• 2014 DRC SUBMISSION – Proposed revisions to Tucson 2 project

LIST OF PROPOSED CHANGES

The Hub at Tucson II

CHANGES SUBMISSION. **PROPOSED**

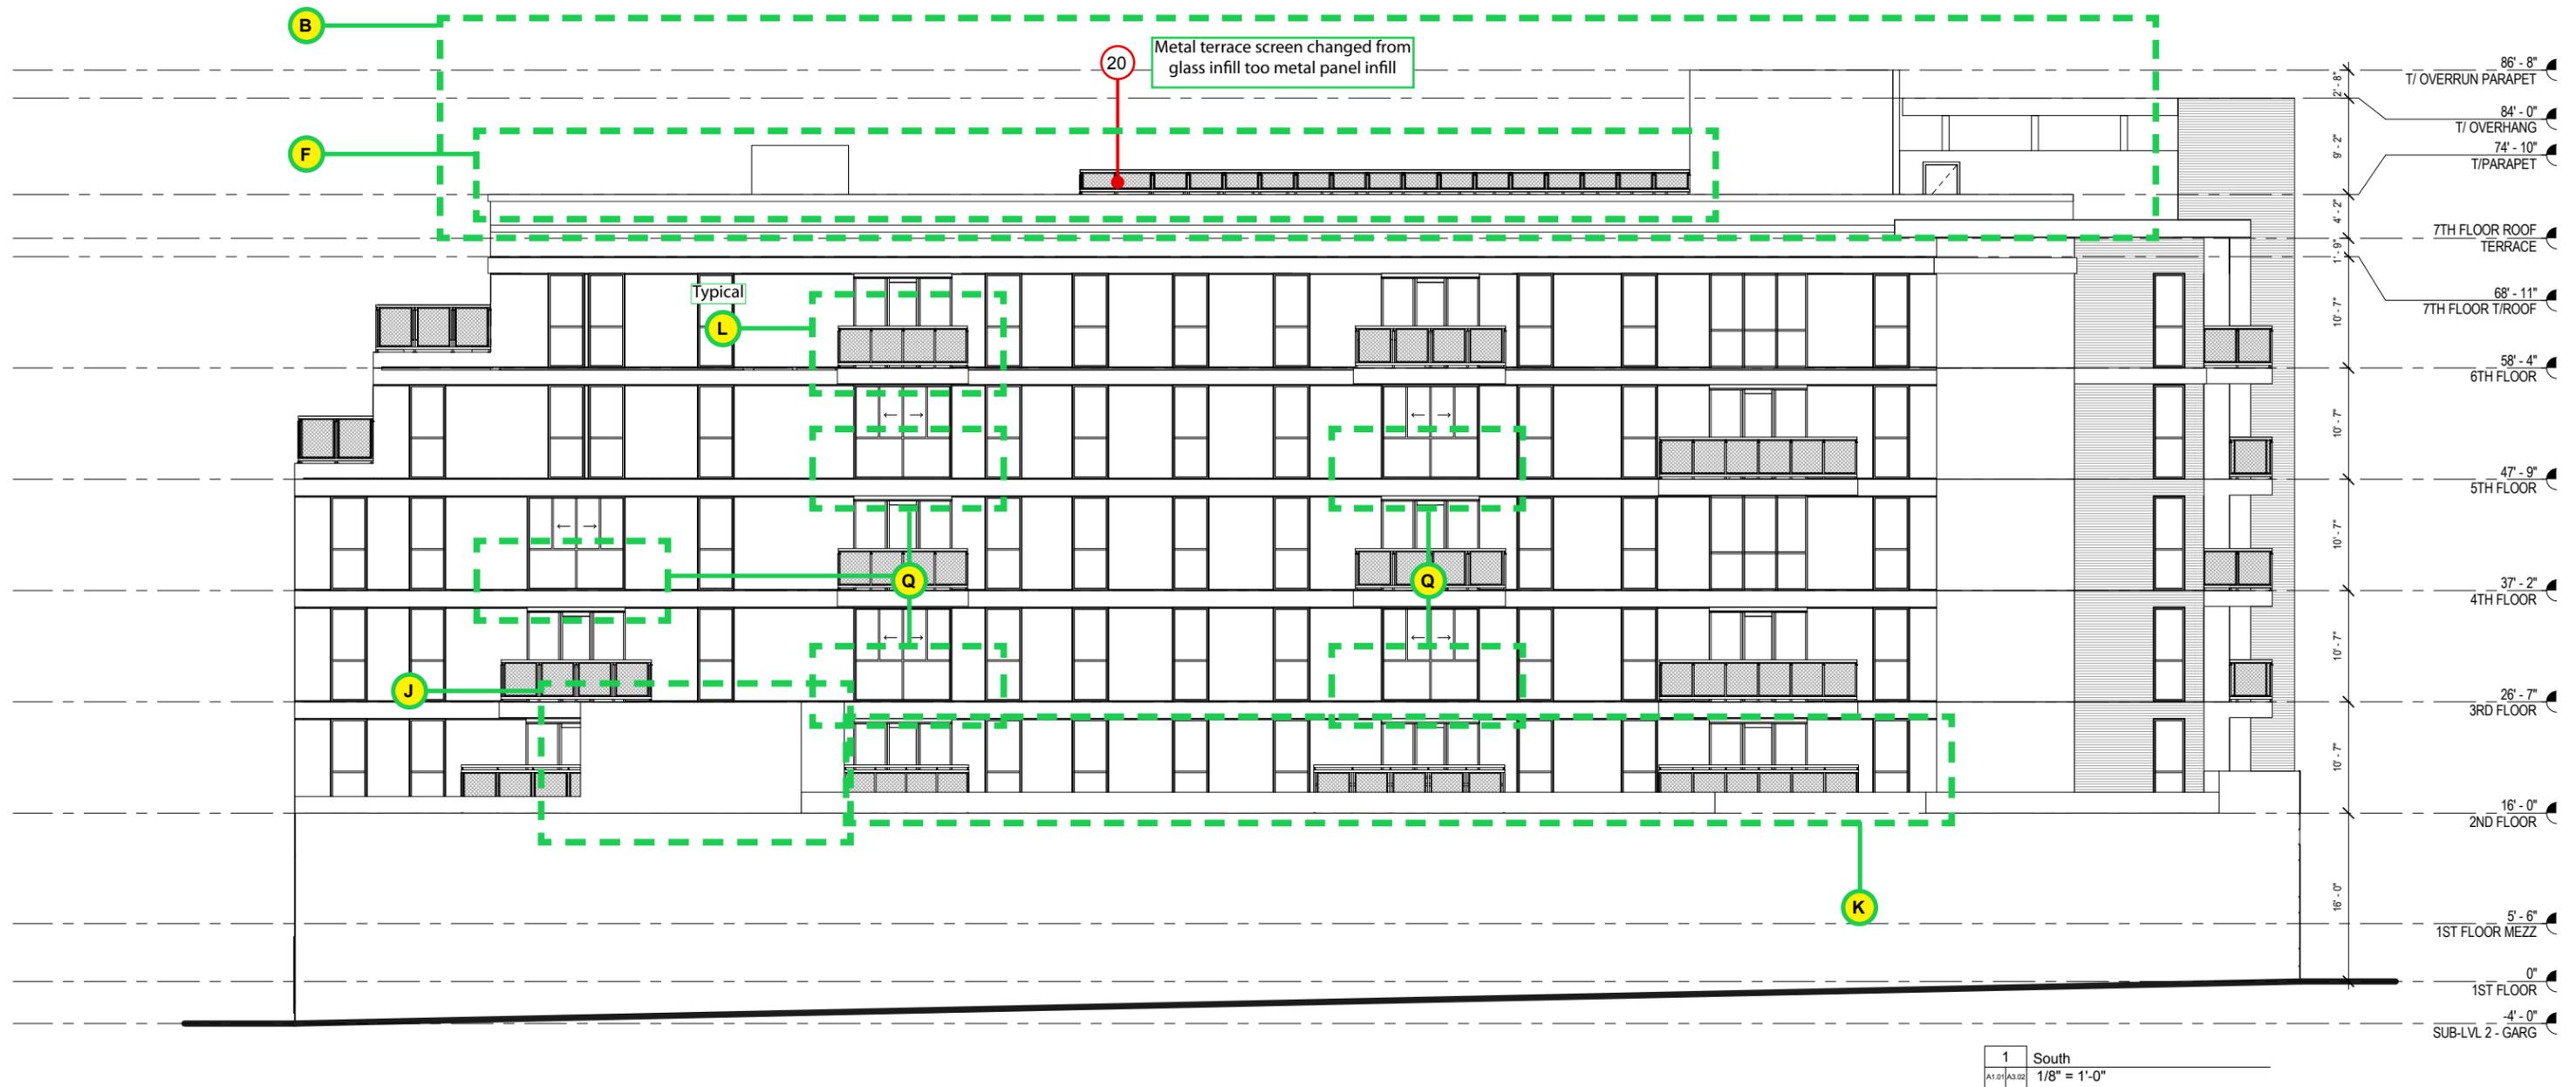
- **B** - Mechanical screen altered. Secondary screen removed and parapet height increase to 5' to act as screen, pool equipment room removed, elevator shaft footprint reduced and the elevator top of parapet height increased from 86' to 90' to allow for the mechanical lift overrun. 6th floor ceiling height increased by 1' with the south "I" eyebrow lifting by approx 1'10".

- **F** - Rooftop terrace area reduced, pool and hot tub relocated to the courtyard. Rooftop terrace screen material changed from glass infill to metal panel infill. Extent of mechanical screen increased to location on the north wing. Landscaping altered to suit new layout.

- **J** - Egress stair enclosure size increased.
- **K** - New roof slab opening to parking below. Landscaping altered to suit new slab openings.
- **L** - All balconies reduced from 6' to 5' deep, excluding balconies on Tyndall street.

- **Q** - Number of balconies reduced on the north and south elevations from 26 to 16.

Proposed Rooftop Plan

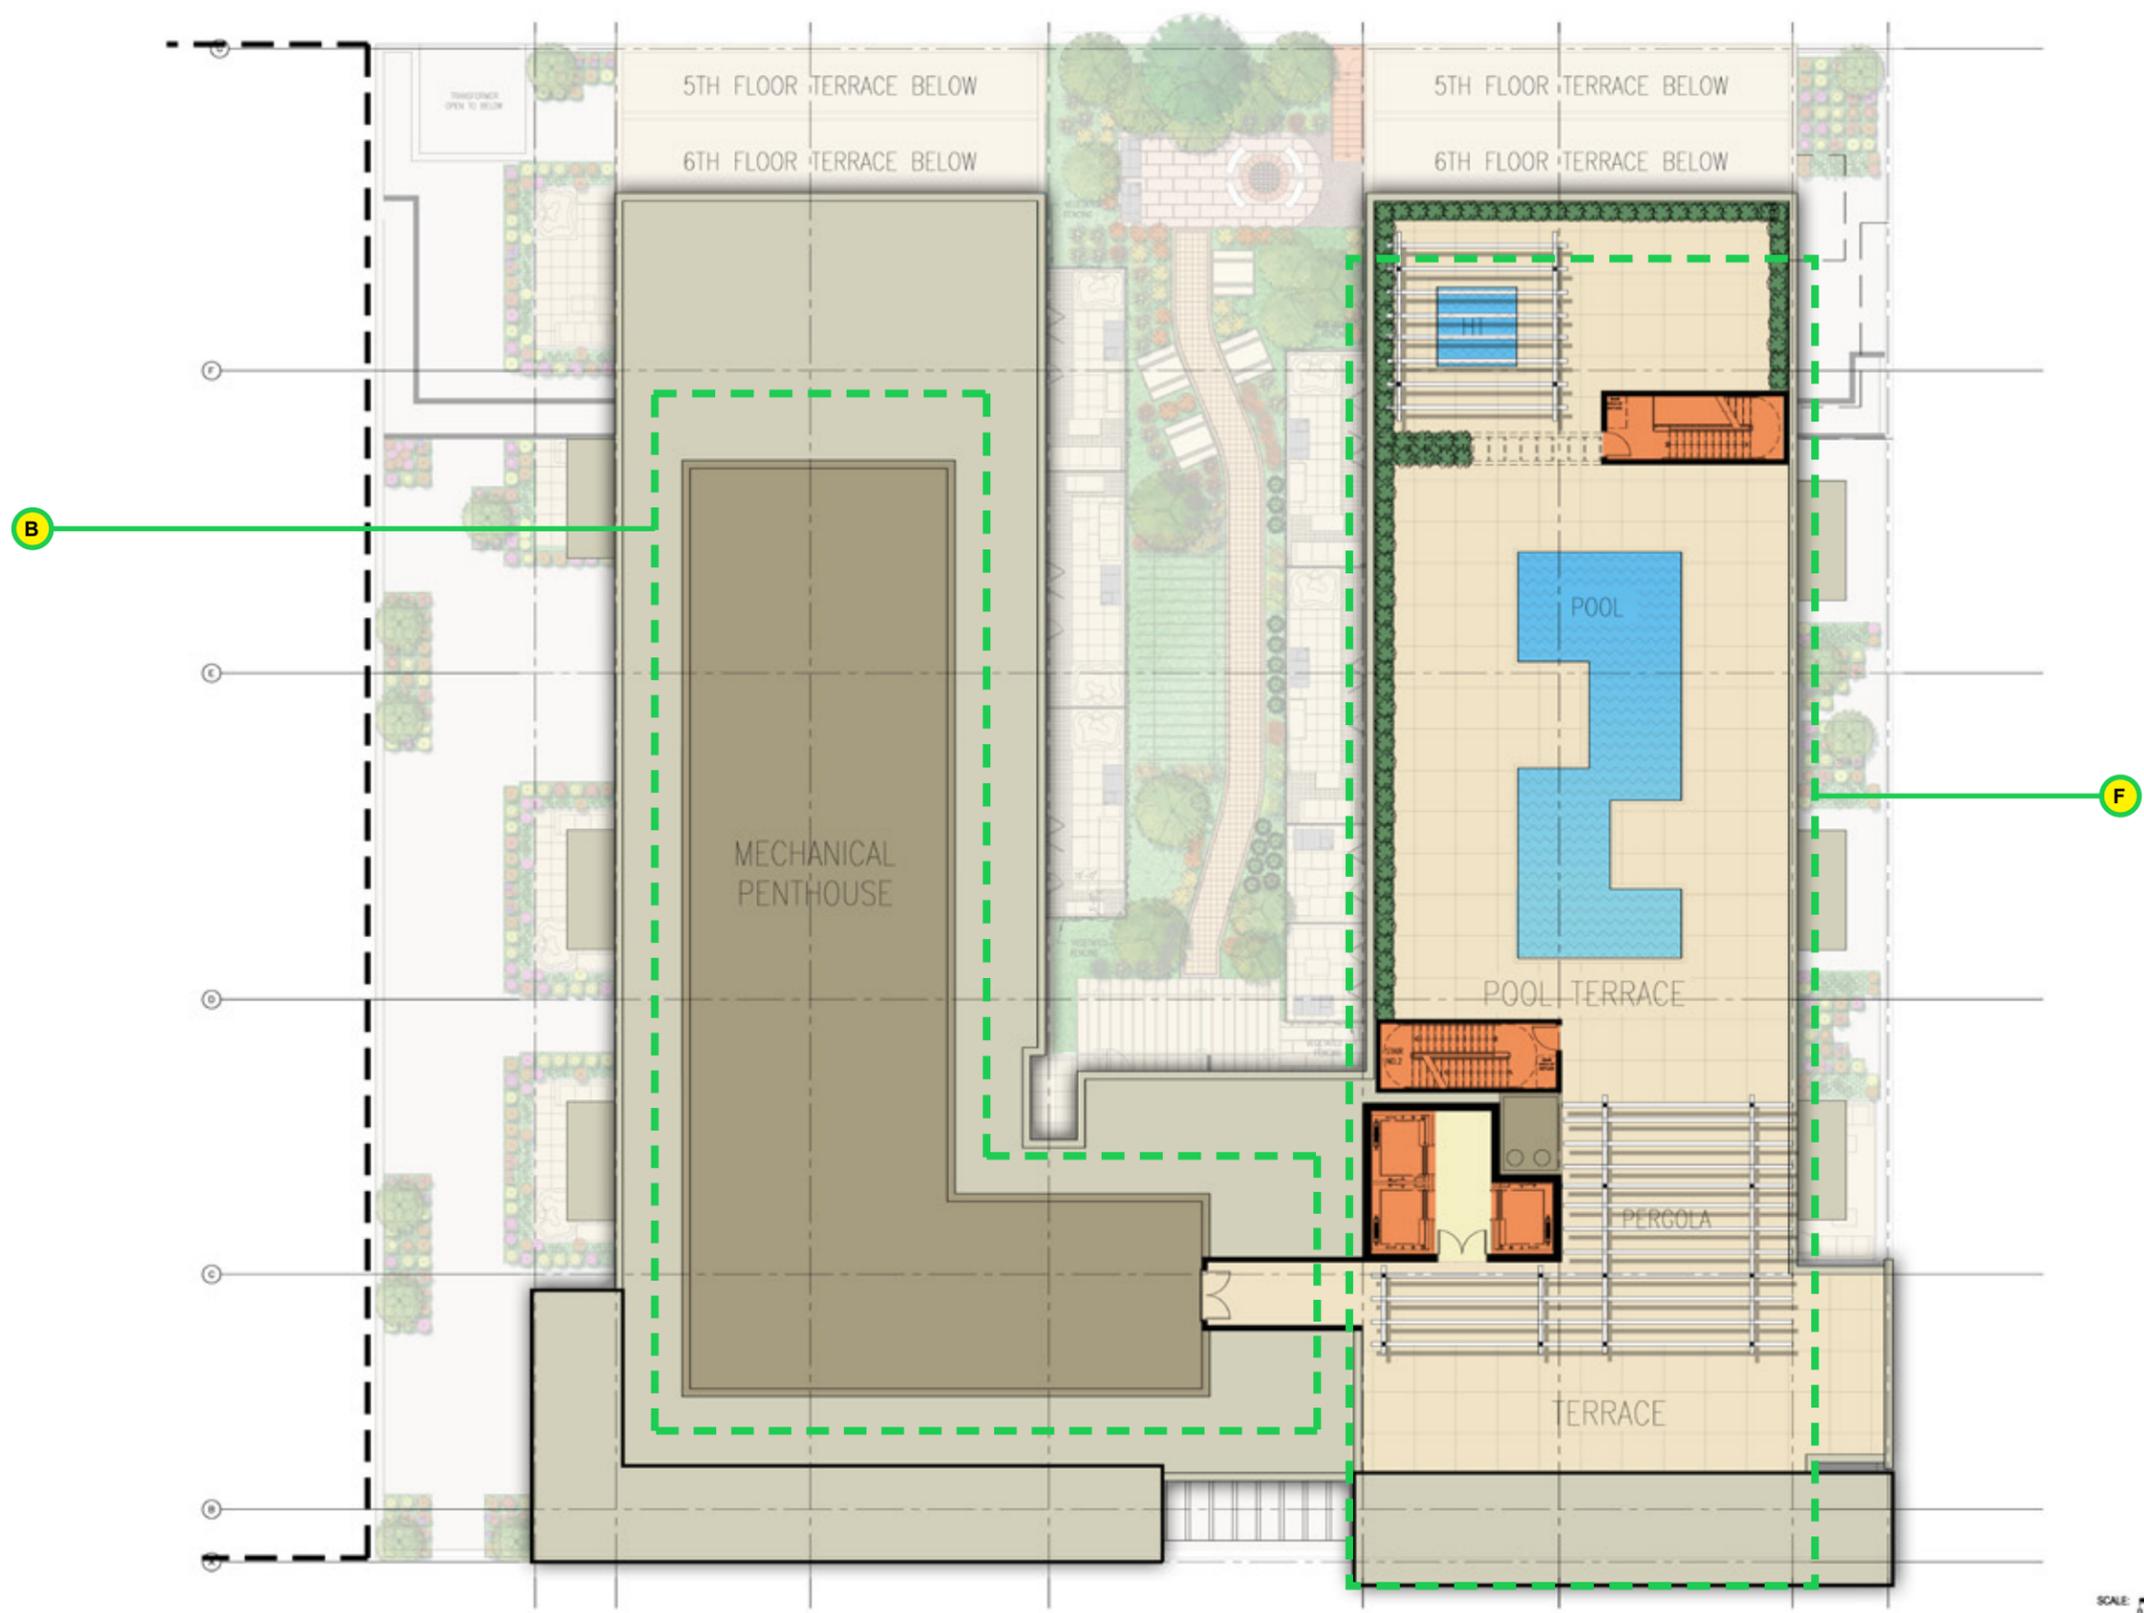
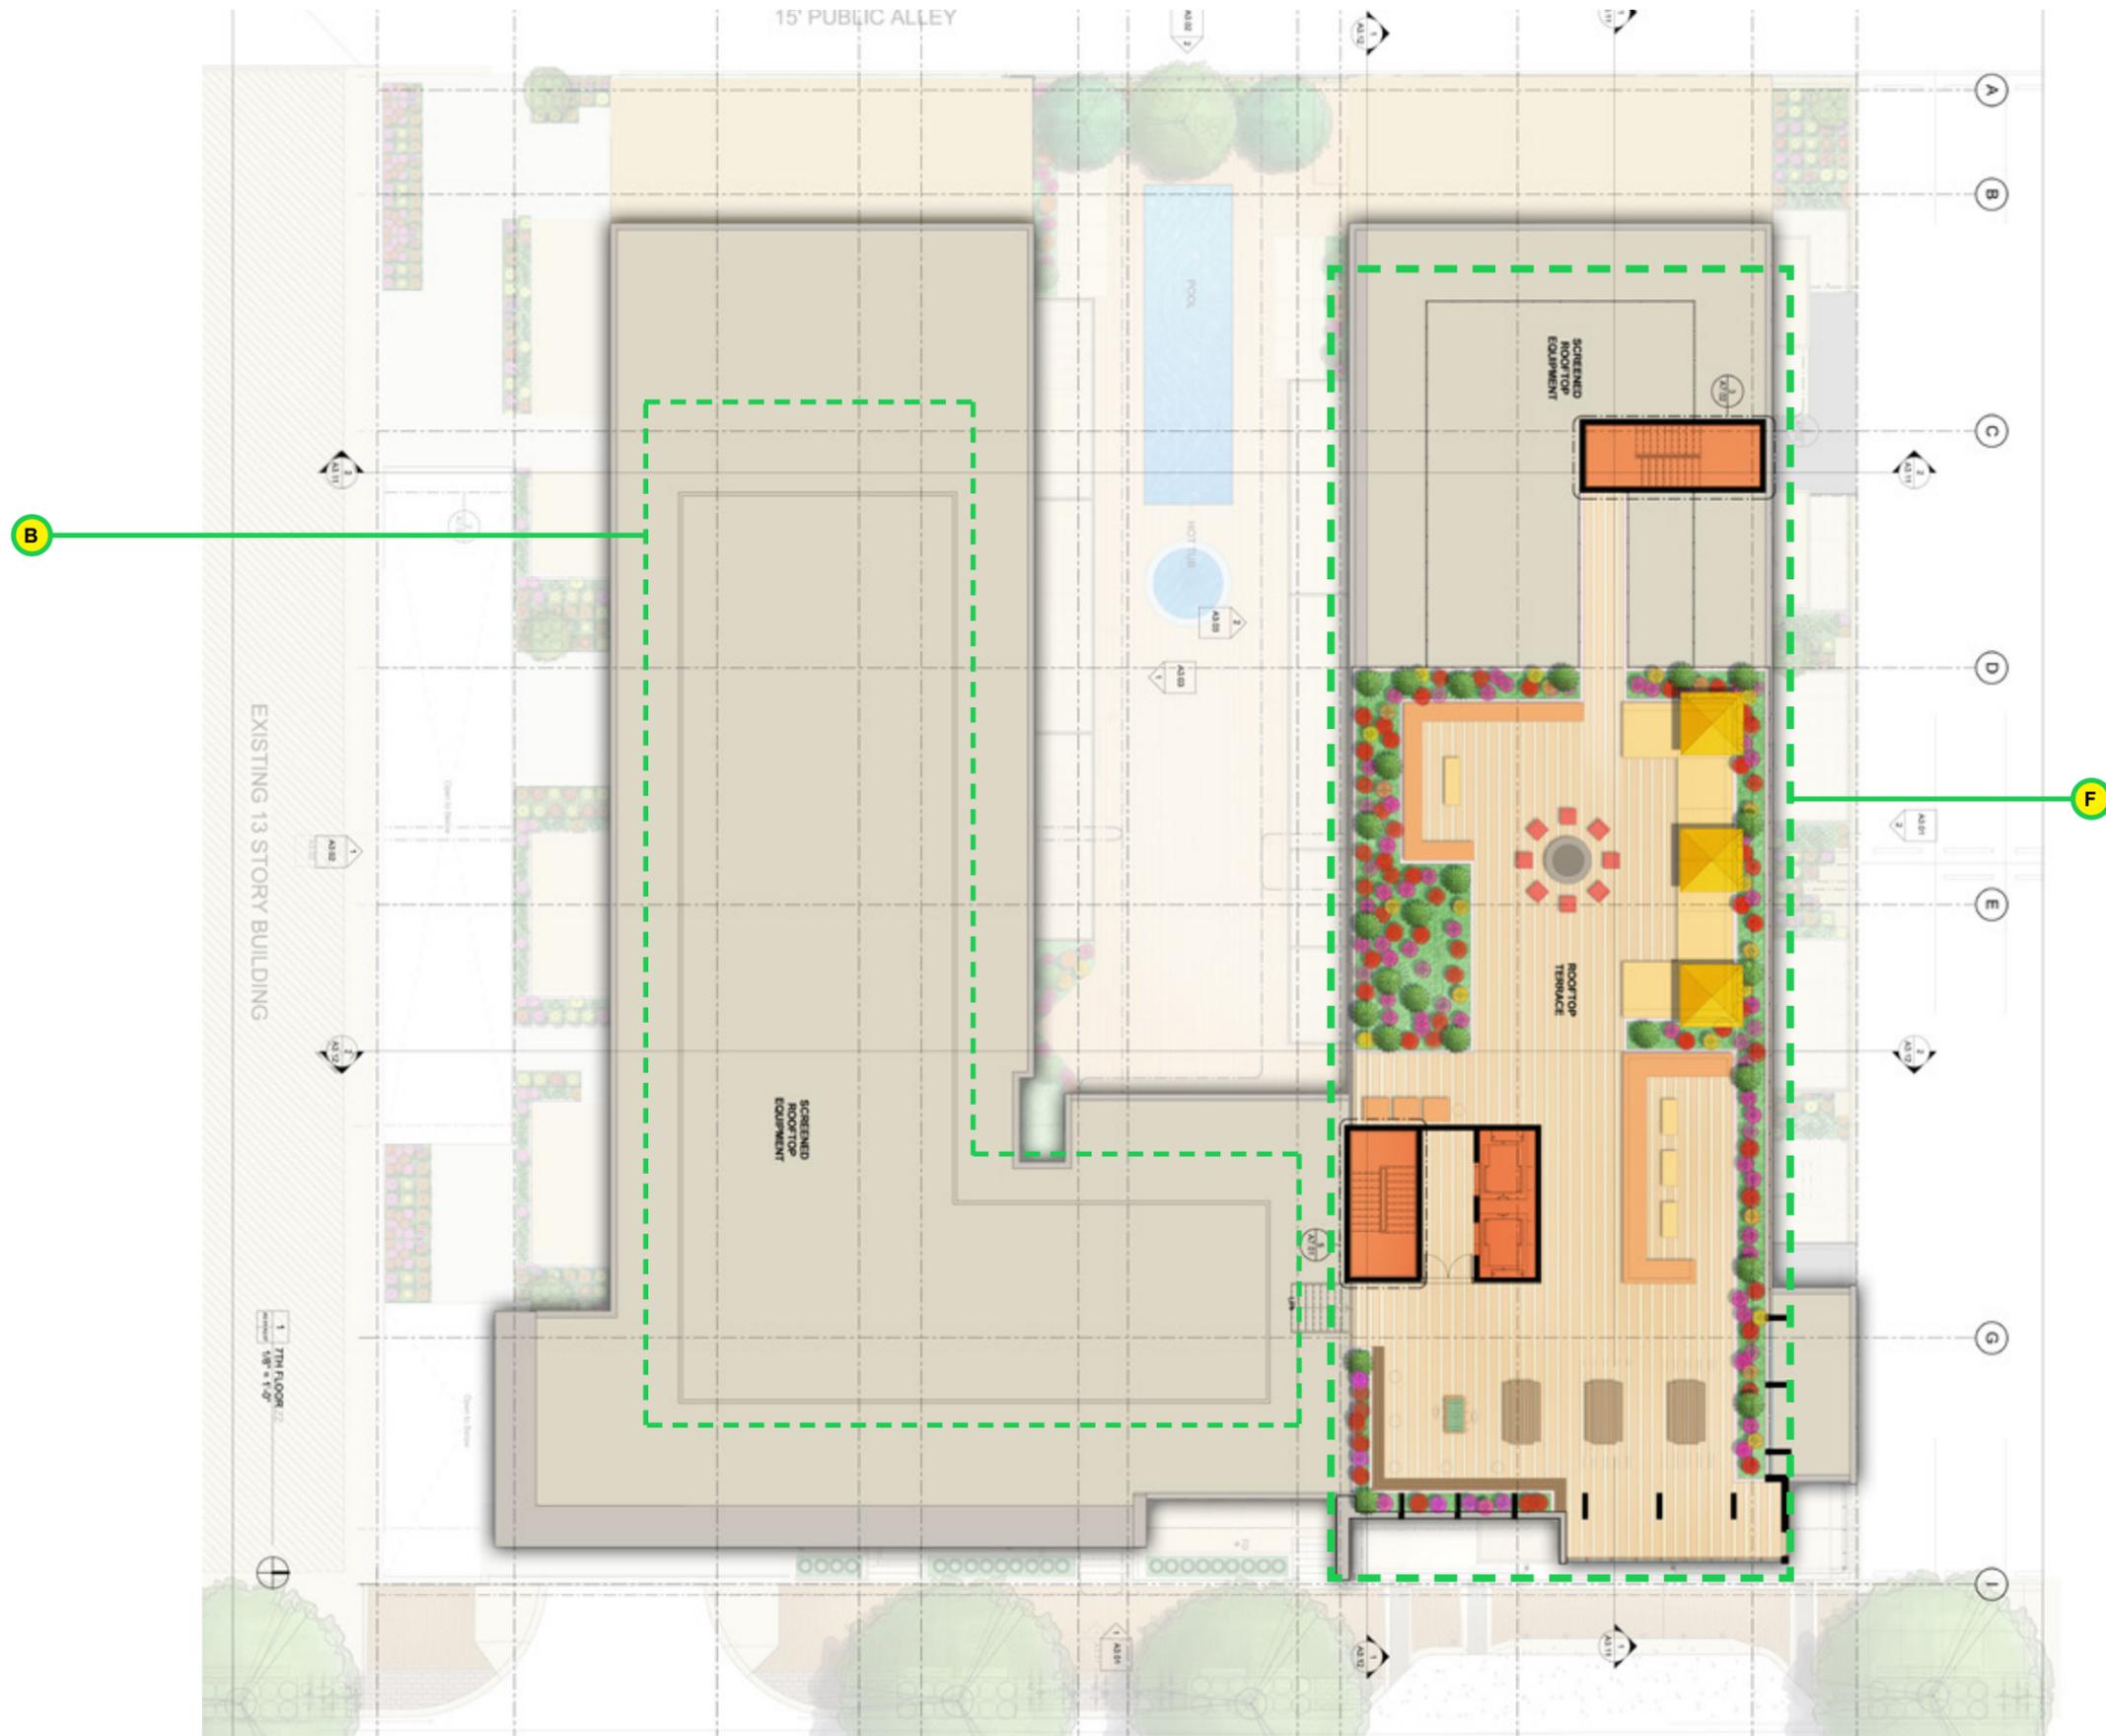
POOL AREA	
APPROVED POOL AREA	828 sqf
